Access Compliance Report

Public Rights-of-Way

(Curb Ramps)

Intersection ID: 31506	Main Street: CHARIDGE_LN	Cross Street: STONEY_CREEK_LN	Location: NE
ADA ID: 9AD5D8921970	Ramp Type: PerpDiag	Initial Pass/Fail: Fail	Overall Compliance: No
Severity Score: 22.5			
Codes/Mitigation Info/Possible Solution		Field Measurements/Component Compliance

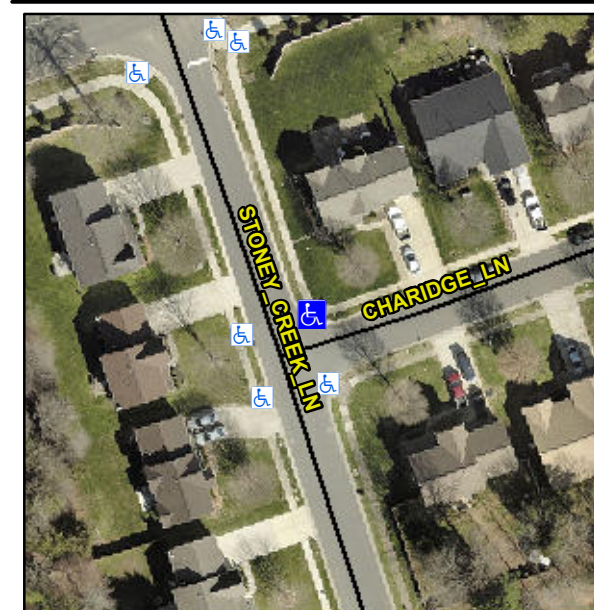
Not Found, R304.5.1, R304.2.2, R304.5.3

Compliance	Description	Data	Compliance	Description	Data
N/A	Ramp Length (in)	47.0	No	Ramp Slope (%)	9.0
No	Ramp Width (in)	43.5	No	Ramp XSlope (%)	3.1
N/A	Flare Type LT	N/A	N/A	Flare Type RT	N/A
N/A	Flare Slope LT (%)	N/A	N/A	Flare Slope RT (%)	N/A
N/A	Flare Traversable LT?	N/A	N/A	Flare Traversable RT?	N/A
N/A	Landing Length (in)	N/A	N/A	DWS Provided?	N/A
N/A	Landing Width (in)	N/A	N/A	DWS Contrast?	N/A
N/A	Landing Slope (%)	N/A	N/A	DWS Length (in)	N/A
N/A	Landing X Slope (%)	N/A	N/A	DWS Full Width?	N/A
N/A	Landing Curb? (Y/N)	N/A	N/A	DWS Offset (in)	N/A
N/A	Shared Landing?	N/A			
N/A	Gutter Ponding?	N/A	N/A	Gutter Slope (%)	N/A
N/A	Gutter Lip Ht (in)	N/A	N/A	Gutter X Slope (%)	N/A
N/A	Painted X Walk1?	No	N/A	Painted X Walk2?	No
	X Walk 1 Direction	To W		X Walk 2 Direction	To S
N/A	X Walk 1 Width (in)	N/A	N/A	X Walk 2 Width (in)	N/A
	X Walk 1 Slope (%)	3.8		X Walk 2 Slope (%)	0.0
	X Walk 1 X Slope (%)	2.2		X Walk 2 X Slope (%)	2.9

Remove & Replace Curb Ramp With Two New Directional Ramps or Equivalent.
